**MODIFICATION REQUEST:
Residential Buildings R8 and R9, Barangaroo South
MP 11_0002 MOD 1**

Secretary's Environmental Assessment Report
Section 75W of the
Environmental Planning and Assessment Act 1979

February 2015

Figure 3: R8 East Elevation (Proposed)

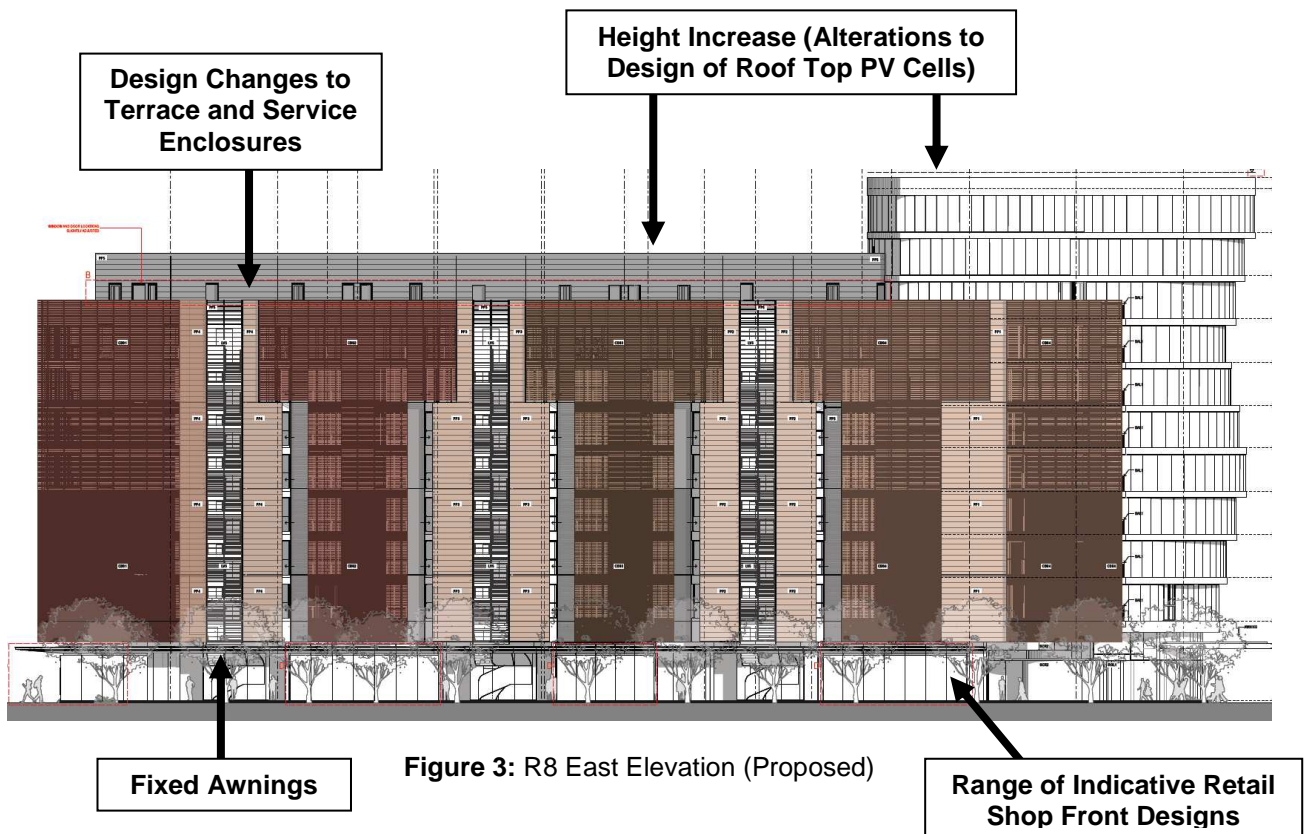
The proposed increase in the building height is a result of alterations to the design of the roof top PV cells (see **Figures 3 and 5**), which are now proposed to be tilted (previously flat) to optimise solar yield. The proposed revised design of the rooftop PV cells would increase the height of building R8 by 0.4 m to 41.9 m, 0.4 m above the maximum building height control for Block X in the MD SEPP. The height of building R9 would also increase as a result of the revised design of the roof top PV cells (by 0.5 m), however this building would remain below the maximum building height control in the MD SEPP.

The modification application includes the provision of a fixed awning above the retail shop fronts along the eastern elevation of building R8, and retractable awnings above the retail shop fronts along the eastern elevation of building R9.

The Government Architect did not support the proposed retractable fabric awnings to building R9 and considered that retractable awnings will impact design excellence, and raised particular concerns regarding the suitability of providing fabric awnings at corner locations. The Government Architect also identified it did not support non-continuous awnings to building R8, and that permanent, continuous footpath protection should be provided in order to promote a high amenity pedestrian environment.

The proposed modification seeks approval for alterations to the design of the roof top PV cells, which are now proposed to be tilted (previously flat) to optimise solar yield. The Government Architect generally supported the revised design of the PV cells, including the exceedance of the height limit discussed previously in Section 5.1.1 of this report, however concern was raised regarding potential impacts of the change in angle of the PV cells, including potential reflectivity impacts.

The RTS identified that the proposed retractable fabric awnings to building R9 are intended to soften the strong concrete elements of the design of the building and introduce a more human scale along Lime Street. The awnings would be constructed of high quality durable material to withstand the elements, and the operable awnings would be carefully detailed to be flush with the shopfronts when retracted. The powder coated elements of the awning would match the rest of the shopfront. The RTS also identified that a continuous fixed awning is proposed generally along the entire length of Lime Street which would provide for permanent, continuous footpath protection, which addresses the concerns raised by the Government Architect.

The Department therefore concludes that the proposed awnings are acceptable. Notwithstanding, pursuant to the existing Condition B4 of the approval, the final detailed design of the awnings will be subject to further approval by the Secretary prior to the issue of the relevant construction certificate.

The RTS confirmed that the PV cells will continue to have a light reflectivity not exceeding 20% in accordance with the existing approval, and that the PV cells will be self-cleaning to reduce requirements for maintenance.
